UNITED STATES PATENT AND TRADEMARK OFFICE

10/554,182

Office Action Summary

DETAILED ACTION

FIG. 7

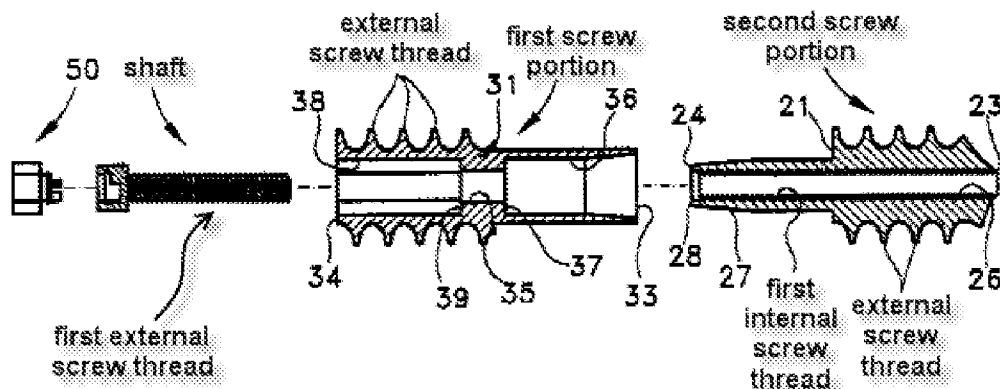
a. Concerning claim 16, 17, and 19, a longitudinal shaft having a head and a longitudinal axis; a first screw portion rotatable about said longitudinal axis; a second screw portion rotatable about said longitudinal axis independently of said first screw portion, wherein said first and second screw portions each have an external screw thread having a first thread direction and configured to engage a bore formed in the first and second members (see Fig. 2 in Bramlet and modified Fig. 7 below).

b. Concerning claim 18, 23, and 24, element 250 can be considered a lock nut; the shaft would be at least flexible to a small degree; first and second members are bone (see Fig. 2);

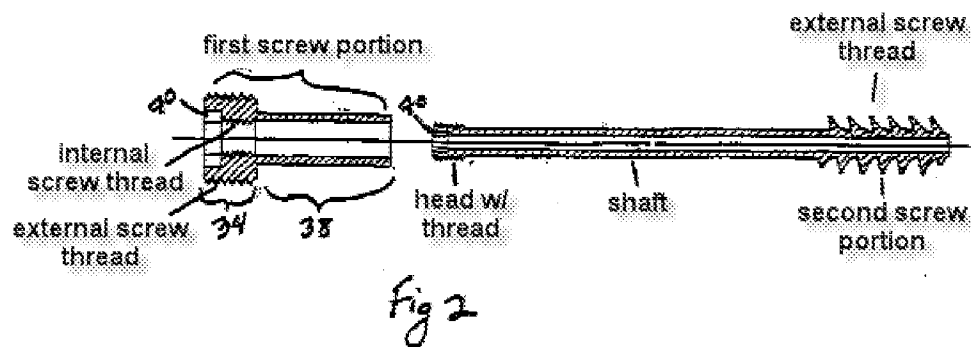
c. Concerning claims 1, 15, 16, and 20, Kyle teaches a shaft having a head and a longitudinal axis; a first external screw thread on said head; a first screw portion; a first internal screw thread on said first screw portion for engaging said first external screw thread; and a second screw portion; wherein the first and

second screw portions each have an external screw thread (see modified Fig. 2 below), but not specifically that the screw thread on the head is in a different direction then the external thread on the screw portions. Asnis et al. teaches a having a different direction thread on a head portion 24 then on a second screw portion 26 in order to allow a first screw portion 52 to be used both as a insertion means and a compression means for the implant (see col. 6, l. 34-53). It would have been obvious to someone of ordinary skill in the art at the time of the invention to have different direction screw threads on in the invention of Kyle, in view of Asnis et al., in order to allow the first screw portion to be used both as an insertion means and a compression means for the implant. The method claim would naturally follow using the device as shown in Fig. 6 and 7 and described in ¶ 19.
